# UNITED STATES PATENT AND TRADEMARK OFFICE

### Office Action Summary

10/563,368

DE BEEN ET AL.

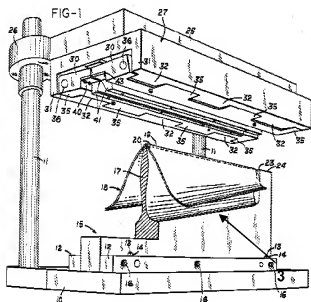
Limitations from claim 16, method for the production of a semi-finished product (18, figure 1 above) for a wing-shaped element (figure 9 above) having, in cross-section, a front edge (20, figure 9 above), a rear edge (21, figure 9 above) and an arched bottom wall (1—added by examiner, figure 9 above) and an arched top wall (2—added by examiner, figure 9) that extend some distance apart between the front edge (20) and the rear edge (21), comprising the following steps: providing a metal sheet (18), bending the sheet (18) with the formation of two panels (1, 2) as well as a curved region (2) which the panels (1, 2) adjoin, providing a former (15, 17), the exterior of which has the shape of the internal surface of the finished element (17), placing the former (15, 17) in the bent sheet (18) with the front edge of the former (15 and 17) positioned in the curved region (2), providing an edge press (figure 4 above) provided with a pressure member (figure 2), fixing the former (15, 17) to the pressure member (figure 2), removing the former (15, 17) with shaped sheet (18) from the edge press (figure 4), placing the shaped sheet (18) in a rubber press provided with a bottom block having a cavity (51) which has a shape that at least approximately corresponds to the external shape of one of the walls (1, 2) of the shaped sheet (18). (column 1, lines 8-20)

Limitations from claim 17, method according to claim 16, wherein the two panels (1, 2) are arched before, or at the same time as bending the sheet (18). (column 1, lines 21-23)

Limitations from claim 18, method according to claim 16, comprising bending the curved region (2). (column 1, lines 21-23)

Limitations from claim 19, method according to claim 16, comprising bending the curved region (2) (column 1, lines 21-23)

Limitations from claim 20, method according to claim 16, comprising constructing the rear edge using a section (21) that is fixed to the top wall (1) and the bottom wall (2) with the formation of a wing-shaped element (figure 9). (column 1, lines 66-71)

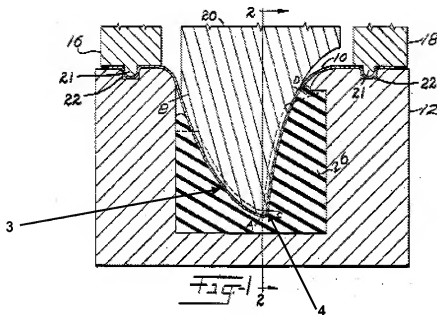
Limitations from claim 24, element (figure 9) according to claim 23, wherein the panels (1, 2) and the body (3—added by examiner, figure 9) are fixed to one another by rivets (not shown in figures), bonding and the like. (column 1, lines 10-13)

Limitations from claim 25, element (figure 9) according to claim 23, wherein the surfaces (1, 2) of the body (3) facing away from one another run obliquely with respect to one another in accordance with the run of the panels (1, 2). (figure 9)

Limitations from claim 26, element (figure 9) according to claim 22, wherein the panels (1, 2) are fixed directly to one another. (figure 9)
